**ADDENDUM #3**  
RIVERSIDE COMMUNITY UTILITY AND STREET IMPROVEMENTS  
CITY OF DULUTH  
PROJECT No. 0699SN/TR  
BID No. 11-0512  
October 12, 2011

**FIRE HYDRANT SETTING DETAIL – HDPE**

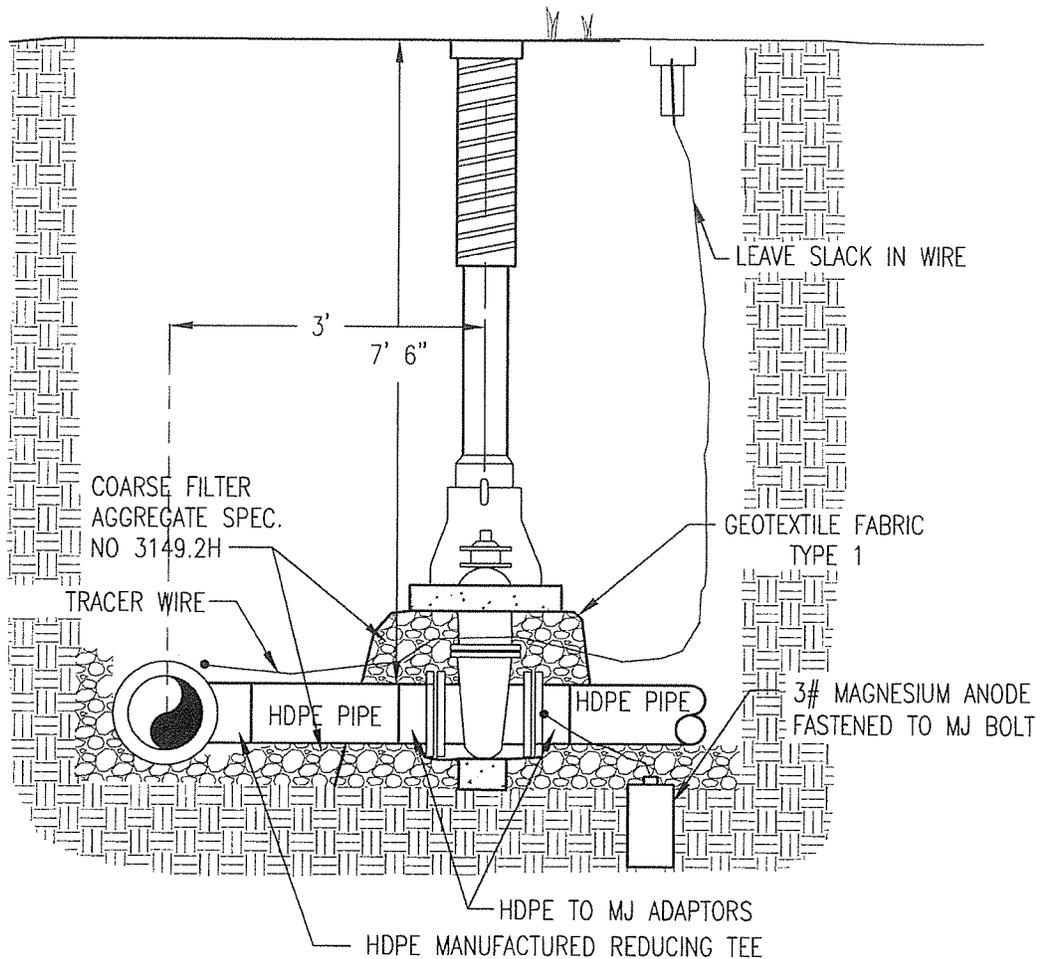
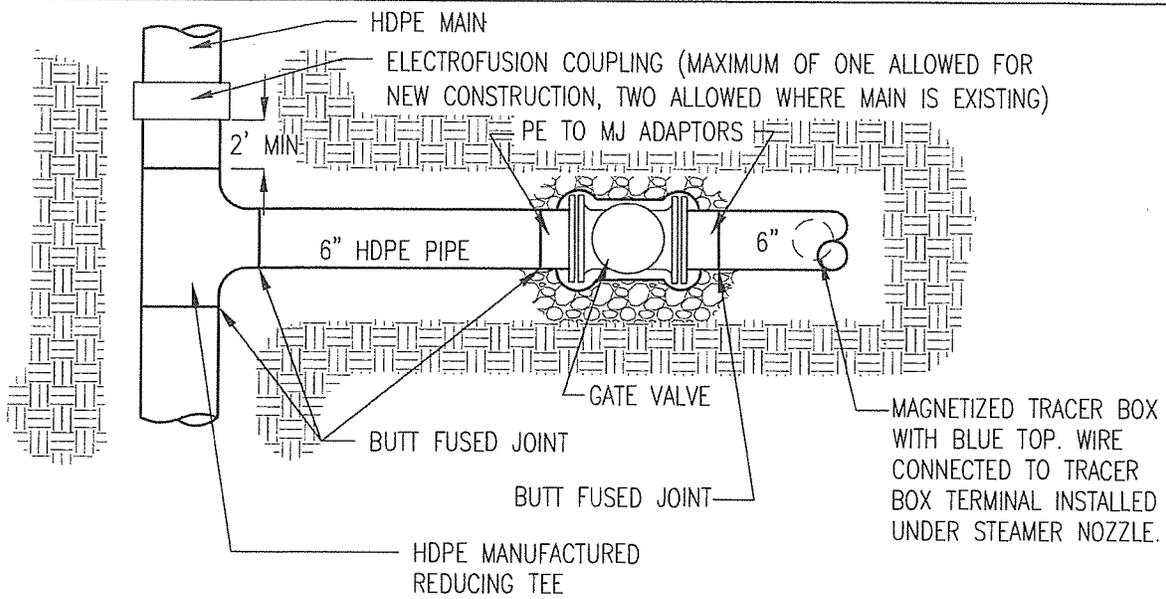
1. The Fire Hydrant Setting Detail - HDPE detail (W-4A) and Water Valve Box – HDPE Main detail (W-17A) on sheet 78 are revised to include 3# Magnesium Anode as shown on the attached details.

4" & LARGER WATER SERVICE - HDPE

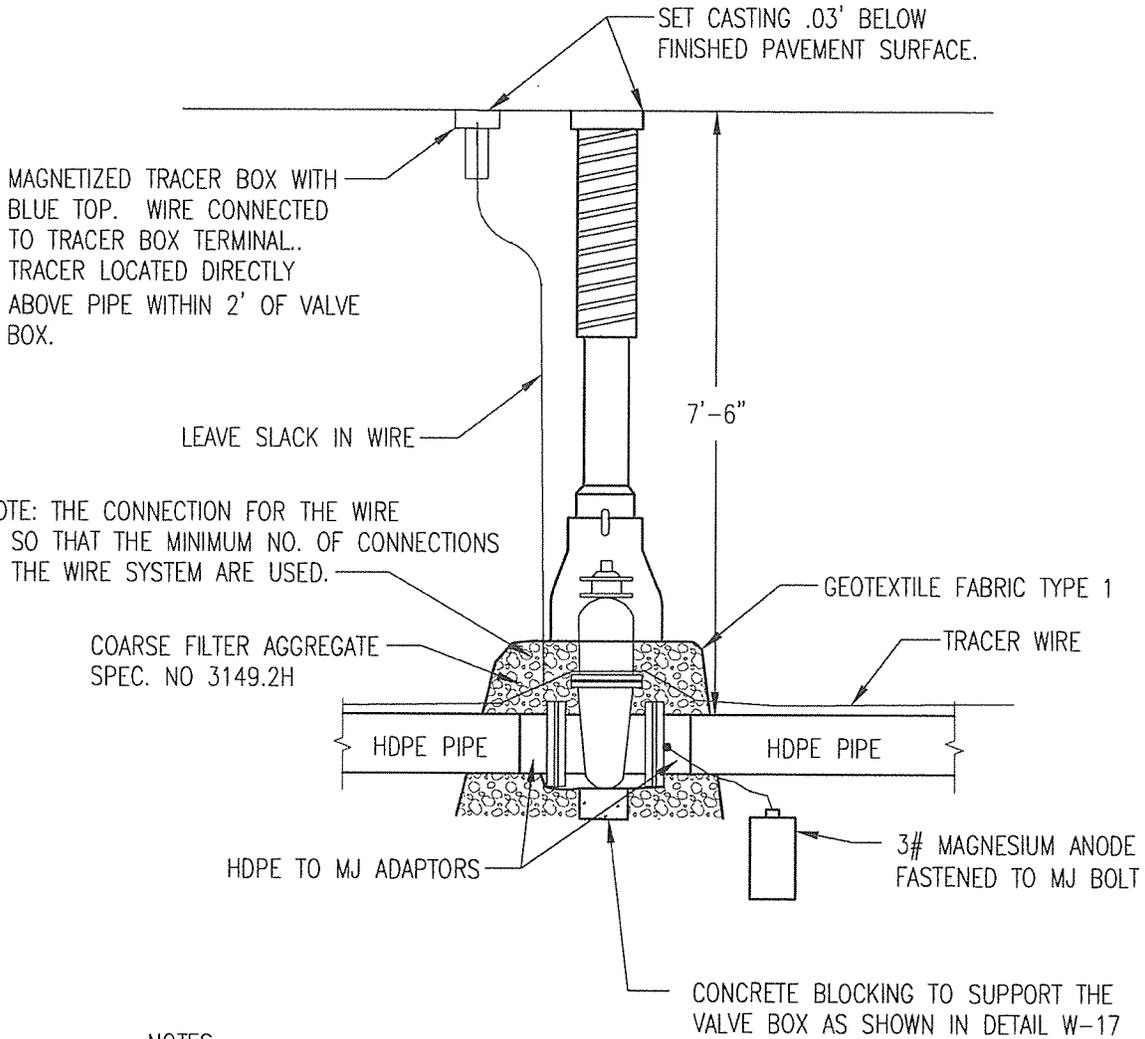
2. The 4" & Larger Water Service – HDPE detail (W-5B) on sheet 80 is revised to include 3# Magnesium Anode as shown on the attached detail.
3. Note number 4 on the Typical Sewer Service Connection detail (SAN-2) on sheet 82 is revised to read as follows:
